APPLICATION FOR PERMIT FOR
HEATING, COOKING OR POWER EQUIPMENT

Location Island Ave., Cliff Island Use of Building dwelling house No. Stories 1 1/2 new Building
Name and address of owner of appliance J. C. James Ward Existing
Installer's name and address R. L. MacVane, Cliff Island Telephone none

AP Island Avenue, Cliff Island-I
(Jerry Cushing)

October 24, 1951

NOTES

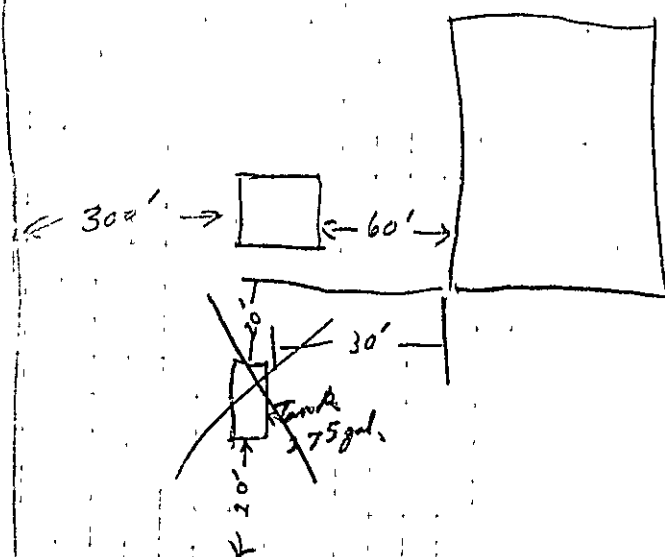
Irrespective of that it seems likely that the Zoning Ordinance will not allow the installation of the above-ground tank closer to the street line than the dwelling house on the same or an adjoining lot. Certainly this is true if the lot is any considerable distance from the Steamboat Landing.

It seems that you have two or three alternatives—relocating the proposed tank so that it will not be closer to the street than the dwelling house, in which case the precise location with relation to the dwelling house and all property lines should be shown on the location sketch; to bury the tank according to the regulations with 2' of ground cover, in which case the tank ought to bear the Underwriter's label for underground use and you might run into the requirement of an auxiliary pump so that the fuel would reach the floor furnace; or to seek a special right from the Zoning Board of Appeals to locate the tank where shown on your sketch. If you adopt the last alternative, it is necessary that you file a more complete and more accurate location sketch showing the side lines of the Cushing property and the relative location to them of the proposed tank, also how close any other habitation on adjoining lots would be to the tank and to the street. It is to be borne in mind in measuring from the street that the measurement must be from the actual line between the public way and private property, not just the edge of the travelled way. In most cases these do not coincide on the Island.

The application states that the tank will be set on concrete piers 6" wide and the piers to set down on solid ledge. Whether or not a metal rack or cradle supported on the piers, will be used to support the tank is not known. At any rate only a suitable shoe or cushion to give bearing for the tank, is permitted to be of wood.

With the tank shown as more than 30' from the house, one wonders how the fuel line to the floor furnace will be cared for and how the required vent pipe will be cared for. Both of these features should be shown clearly on the sketch when the matter is adjusted.
